## IDAP REPORT – SECTION 4.55(1) MODICATION

<b>Property:</b>	27-35 Punchbowl Road BELFIELD Lot 100 in DP 1270355 DA2016.17.5
<b>Proposal:</b>	Section 4.55(1) - Modification Application to edit Condition 1 of the development consent
<b>Applicant:</b>	Eastern Pacific Design & Construct Pty Ltd
<b>Owner:</b>	Investments Pty Ltd
<b>Date of lodgement:</b>	28 October 2021
<b>Notification period:</b>	Not notified
<b>Submissions received:</b>	N/A
<b>Assessment officer:</b>	M Rivera
<b>Estimated cost of works:</b>	\$31,463,039.00
<b>Zoning:</b>	B2 – Local Centre – SLEP 2012
<b>Heritage:</b>	Not a heritage item. Not within a heritage conservation area. Not within vicinity of any heritage items.
<b>Flood affected:</b>	No
<b>RECOMMENDATION OF OFFICER:</b>	<b>APPROVAL</b>

**Figure 2:** Privacy screens drawing.

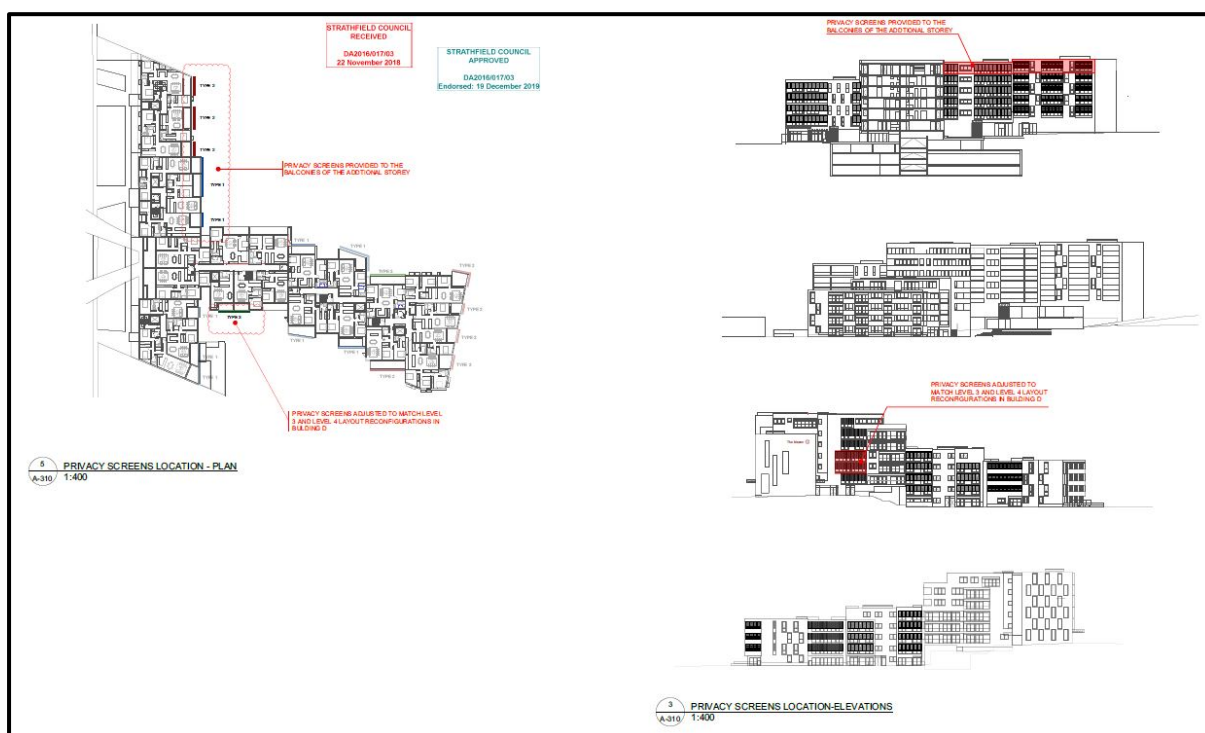
1. Reinstating the following plan that was deleted from Condition 1 and that relates to the approved privacy screens:

**Privacy Screens, Drawing No. A-310, Rev 5, prepared by Olsson & Associates Architects, dated 29/10/2018, received by Council 22 November 2018.**

This drawing is illustrated in Figure 2 below.

It is noted that the approved privacy screens are contained within Levels 3, 4 and 6.

**Privacy Screens, Drawing No. A-310, Rev 5, prepared by Olsson & Associates Architects, dated 29/10/2018, received by Council 22 November 2018.**
